Planning Commission Meeting
Tuesday, May 26, 2020
7:00 pm
Via Zoom

1. **HILLTOP RIDGE**
   FP-20-06: Consider a final plat for approximately 17 acres for Hilltop Ridge 1st Plat for 32 single-family lots located just west and south of the intersection of 167th Street and Kill Creek Road.

PLANNING COMMISSION STAFF REPORT **NEW BUSINESS ITEM NO.1**
MEETING DATE: MAY 26, 2020
PREPARED BY: ROBERT CASE, PLANNER

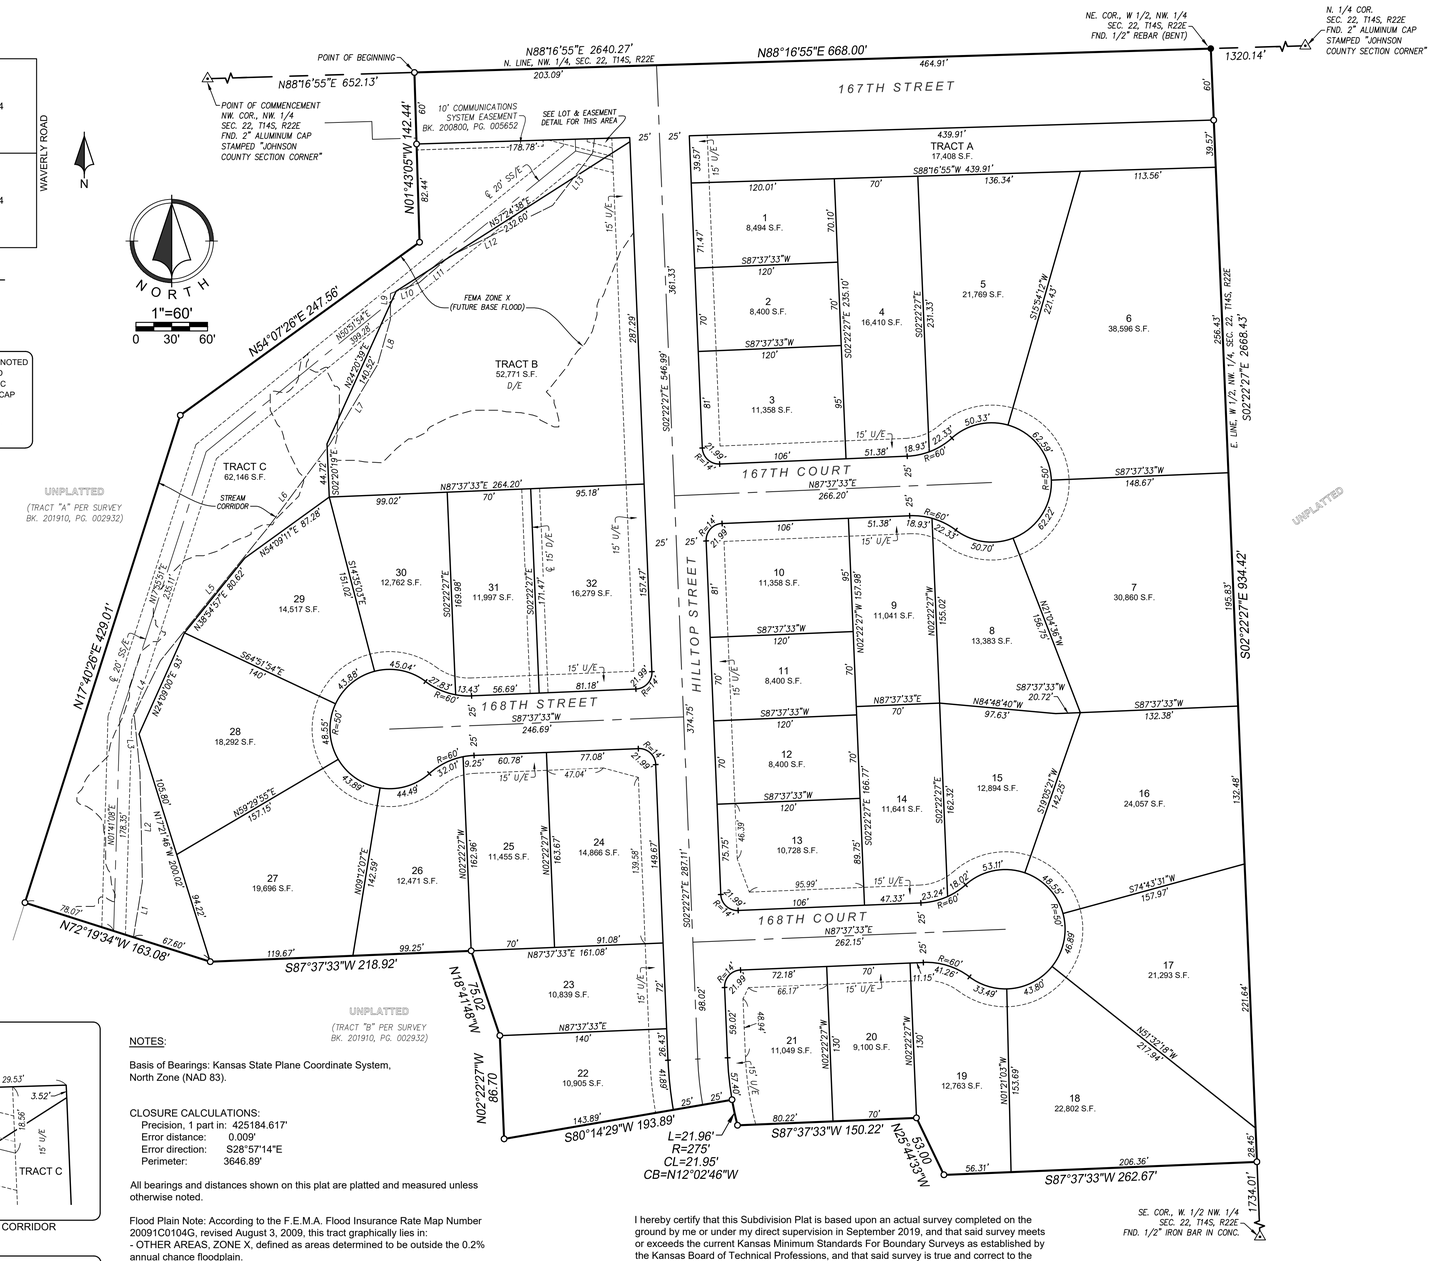
Staff Comment: *The plat meets the site design standards regarding lot size minimum, block length, cul-de-sac length and easements. The plan complies with the requirements of the Gardner Land Development Code in that the blocks and lots proposed can meet all development and site design standards. The development is proposed to be a Detached House - Suburban building type for single-family residential, with a Suburban Yard frontage design type. While this development is within the service area of Celebration Park, they are still dedicating approximately 10% of the space to open and civic space which is private open space. A street tree plan has been submitted and is generally in compliance. A few changes remain to be made to move proposed trees further from intersections. This will be a condition of approval.*

Staff Comment: *Public improvement plans have been submitted but not formally approved. All public improvement plans shall be approved prior to the release of the final plat for recording at the County (this is a recommended condition of approval). The City is the provider for sanitary sewer, water, and electric facilities in this area.*

Staff Comment*: This is the first of five phases for the Hilltop Ridge Subdivision. The next phase will require an additional exit out of the subdivision. The Traffic Impact Study, Stormwater Management Plan and Public Improvement Plans have been submitted but not approved. All Public Improvement Plans shall be submitted and approved prior to the release of the final plat for recording and issuance of building permits to ensure all improvements are in place.*

1. Public improvement plans shall be submitted and approved prior to the release of the final plat for recording at the County.
2. Revise the plat to show Hilltop Street to be named Scott Street.
3. Revise the plat to show 168th Street to be 168th Place.
4. Provide a revised street tree plan based on staff comments, for approval prior to the release of the plat for recording.
5. Prior to the recording of the final plat, excise tax shall be paid to the City.
6. Correct square footage of the subdivision on the legal description.
